JRPP Number	2010SYW064
Application Number	DA10/0938
Local Government Area	Penrith City Council
Applicant	Nettleton Tribe Pty Ltd
Proposed Development	Staged Development - Three (3) x Warehouse Distribution Buildings
Property Description	Lot 2 DP 1094504
Property Address	Nos.1-23 Templar Road, ERSKINE PARK
Date Received	18 September 2010
Type of Development	Integrated Development
Capital Investment Value	\$24,800,000
Assessing Officer	Steven Chong - Senior Environmental Planner
Recommendation	Approval, subject to conditions

Assessment Report and Recommendation

Development Application Plans

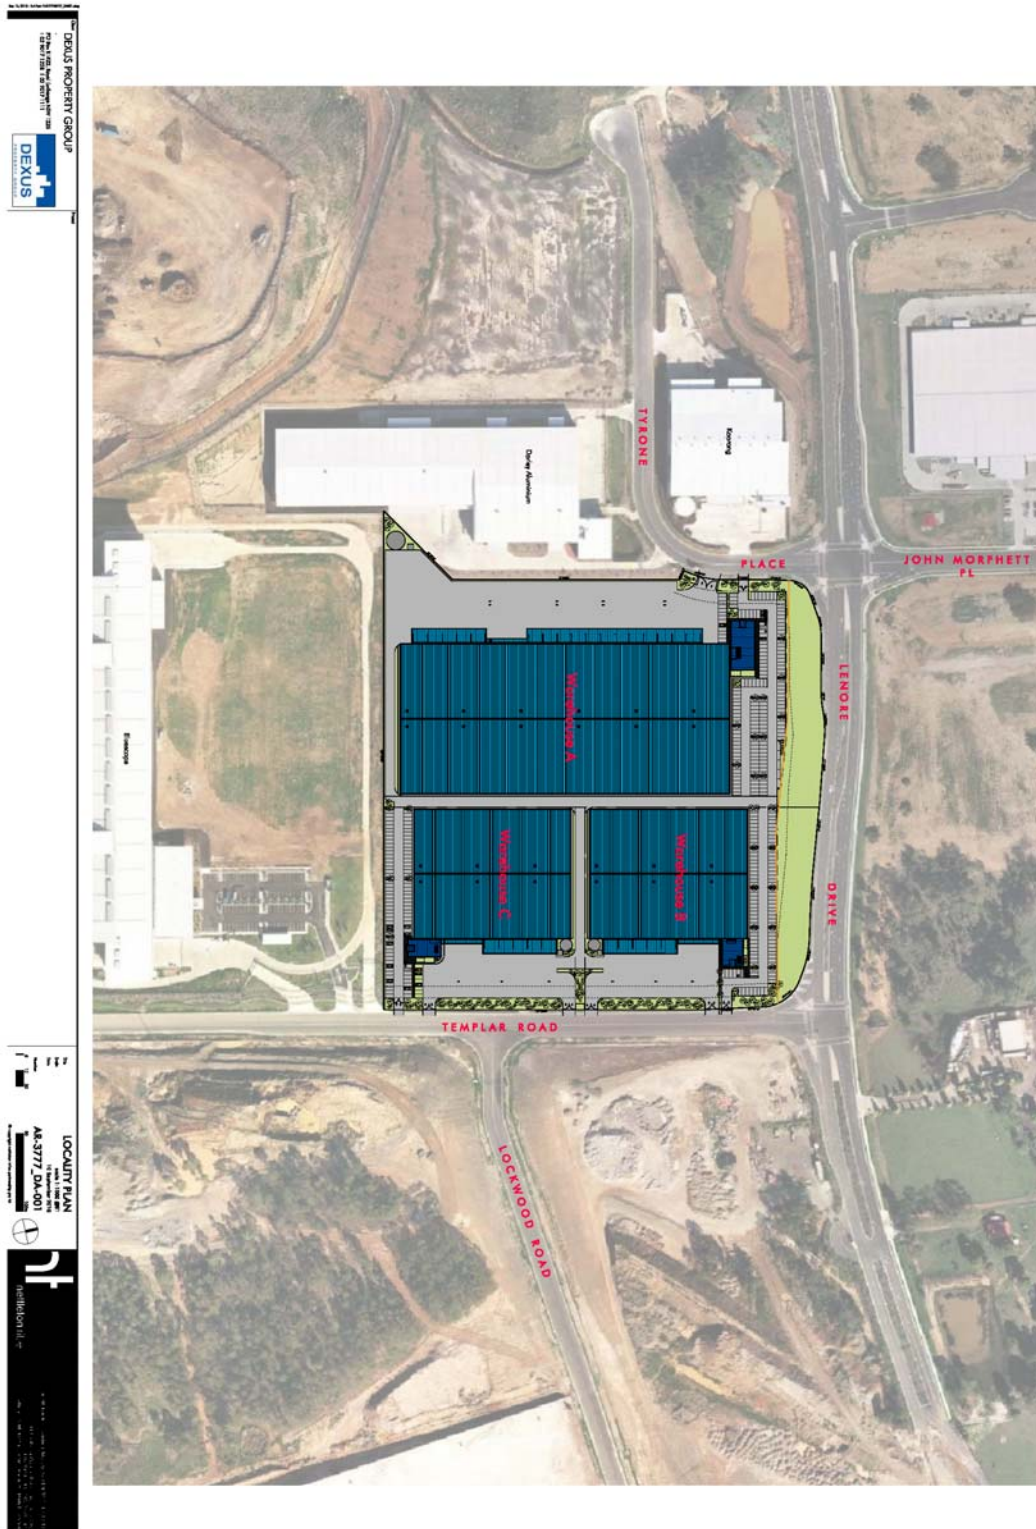
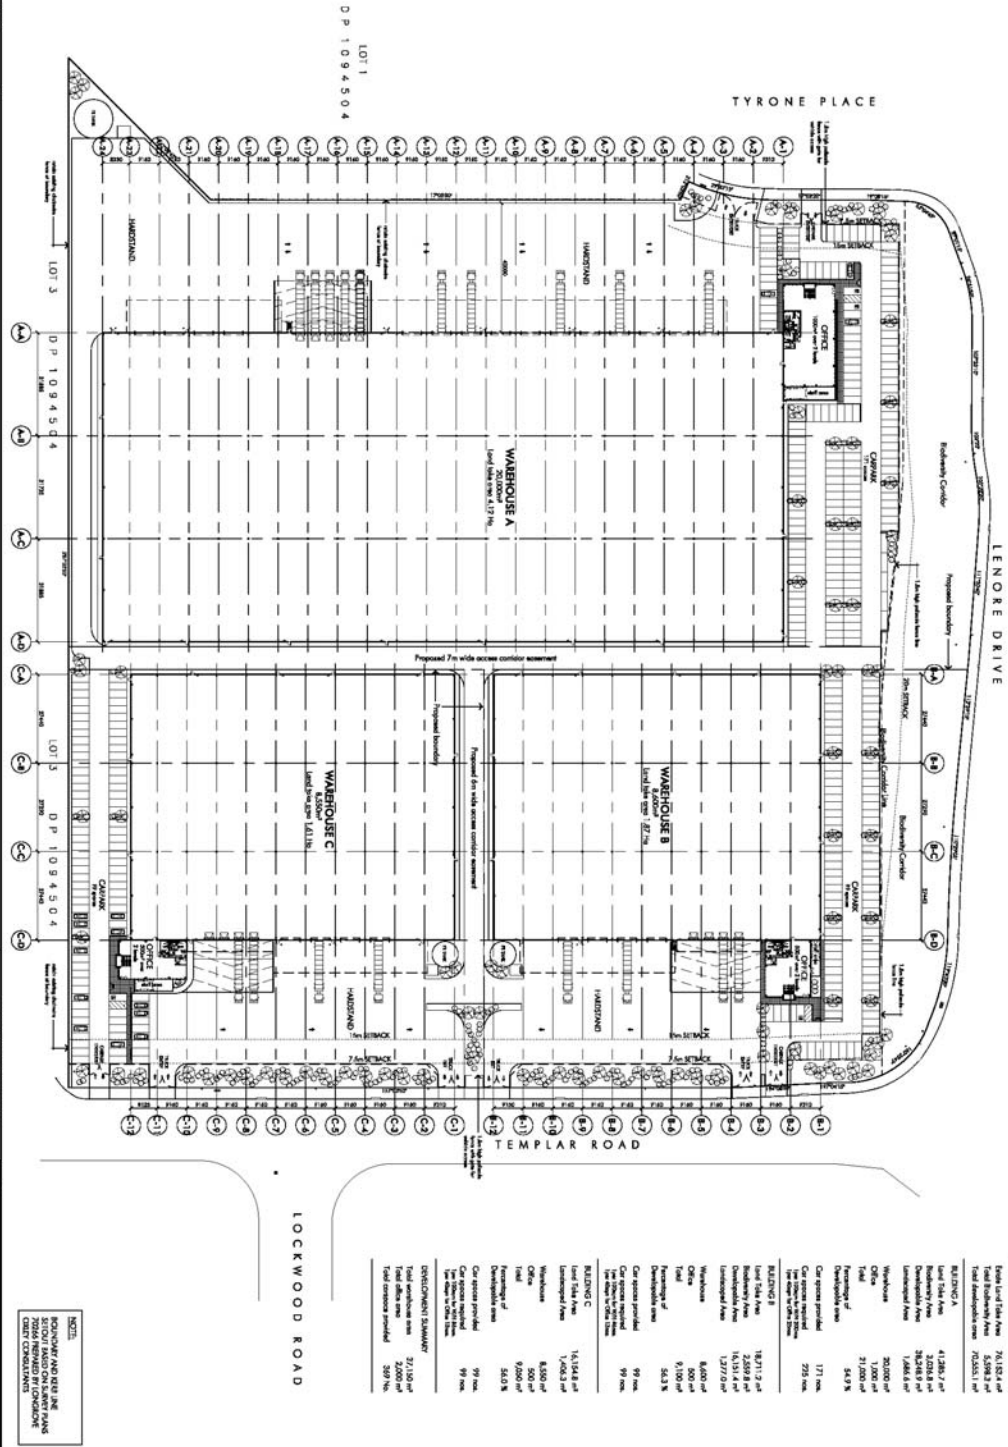
-
-
1. *The location of the entrance and exit to the heavy vehicle loading dock area for 'Building B' are to be reversed with the entrance being located to the south and the exist located to the north of the loading dock area to provide adequate separation between the entry and signalised intersection.*

However, the location of the truck entrance and exit points for proposed Building B are required to be reversed to allow for adequate separation between the entry and the signalised intersection with Templar Road and Lenore Drive.

<ol style="list-style-type: none">1. The location of the entrance and exit to the heavy vehicle loading dock area for 'Building B' are to be reversed with the entrance being located to the south and the exit located to the north of the loading dock area to provide adequate separation between the entry and the signalised intersection.2. The layout of the proposed car parking areas associated with the subject development (including driveways, grades, turn paths, sight distance requirements, aisle widths, aisle lengths, and parking bay dimensions) should be in accordance with AS 2890.1 - 2004 and AS 2890.2 - 2002 for heavy vehicle usage.3. The swept path of the longest vehicle (to service the site) entering and exiting the subject site, as well as manoeuvrability through the site, shall be in accordance with AUSTROADS. In this regard, a plan shall be submitted to Council for approval, which shows that the proposed development complies with this requirement.4. All vehicles are to enter and leave the site in a forward direction.5. All works/regulatory signposting associated with the proposed development are to be at no cost to the RTA.
